APPEAL SUMMARY

Appeal ID: 19089	Project Address: 2245 NE 36th Ave
Hearing Date: 3/6/19	Appellant Name: Alyssa Leeviraphan
Case No.: B-014	Appellant Phone: 503-224-4032
Appeal Type: Building	Plans Examiner/Inspector: John Cooley
Project Type: commercial	Stories: 3 Occupancy: A, B, E, S Construction Type: 1-A, 2-B
Building/Business Name: Grant High School/Portland Public Schools	Fire Sprinklers: Yes -
Appeal Involves: Alteration of an existing structure, Addition to an existing structure	LUR or Permit Application No.: 17-138459-CO
Plan Submitted Option: pdf [File 1]	Proposed use: Educational

GRANT HIGH SCHOOL
MODERNIZATION

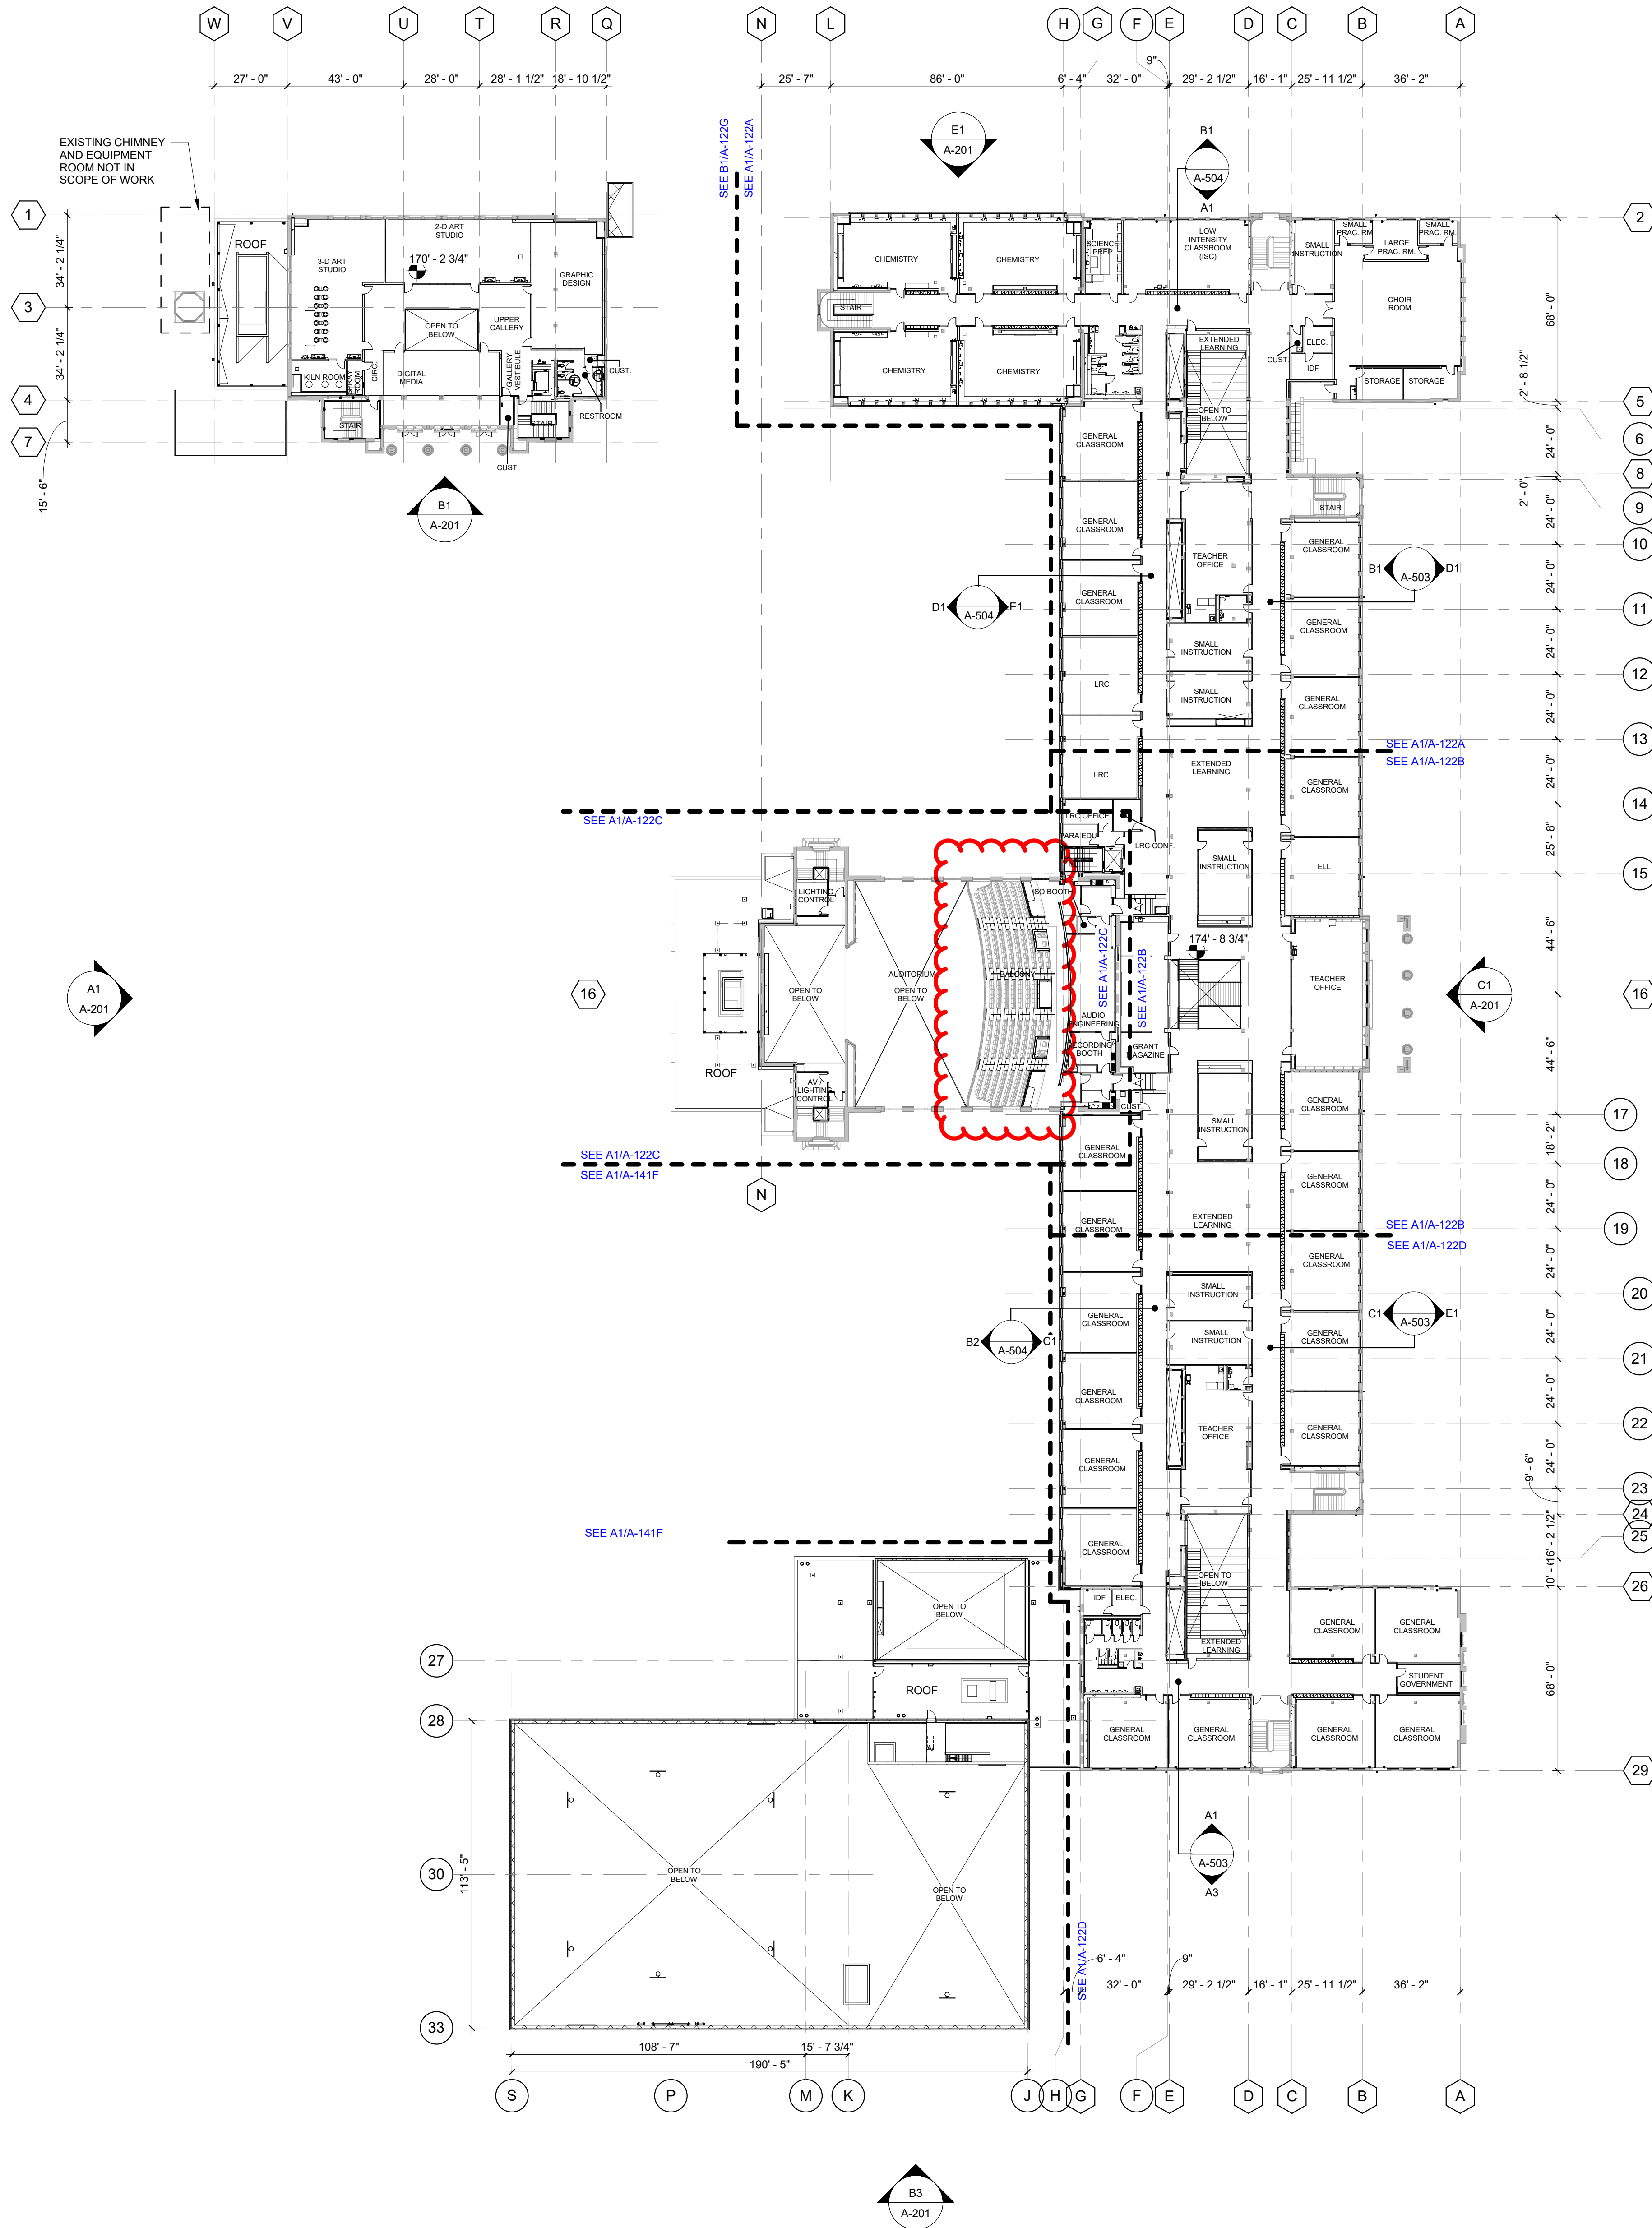
Code Section	1009.7.4
Requires	1009.7.4 Dimensional Uniformity – Stair treads and risers shall be of uniform size and shape. The tolerance between the largest and smallest riser height or between the largest and smallest tread depth shall not exceed 3/8 inch (9.5 mm) in any flight of stairs.
Proposed Design	<p>The existing auditorium balcony currently consists of a series of concrete tiered risers. These risers served as steps in the aisles. Most risers are approximately 10" tall. Under the current permit an intermediate step is being added at each riser in the aisle so that each riser will be approximately 5" tall.</p> <p>However, the contractor has field measured the existing risers and found that at two of the four aisles the top riser is approximately 12" tall rather than 10" tall. We propose to add the intermediate steps as planned at these locations, which will result in the top two stair risers being approximately 6" while the rest of the risers will be approximately 5". The stairs will be finished with carpet with vinyl nosings. If desired, we propose using an alternate contrasting color nosing at the non-conforming stairs.</p> <p>Other related improvements to this condition include the following:</p> <p>In the existing condition there are no handrails and the guardrail at front of the balcony aisle does not meet current code. Handrails are being provided at each aisle and higher guardrails are being added at the end of each aisle to correct each of these code deficiencies.</p>

Reason for alternative	This project includes extensive upgrades to the historic 1927 auditorium, but correction of this non-conforming condition would require demolition of large portions of the existing balcony concrete

floor to marry new stair elevations to the existing conditions. In addition to causing cost and schedule impacts there is potential that the demolition activities would impact the historic ornamental plaster ceiling on the underside of the balcony or have unforeseen structural implications to the cantilevered steel trusses that support the balcony.

Increase in dimensional tolerance between the largest and smallest riser height at alteration to existing stair: Granted as proposed with contrasting color nosing at non-conforming stairs.
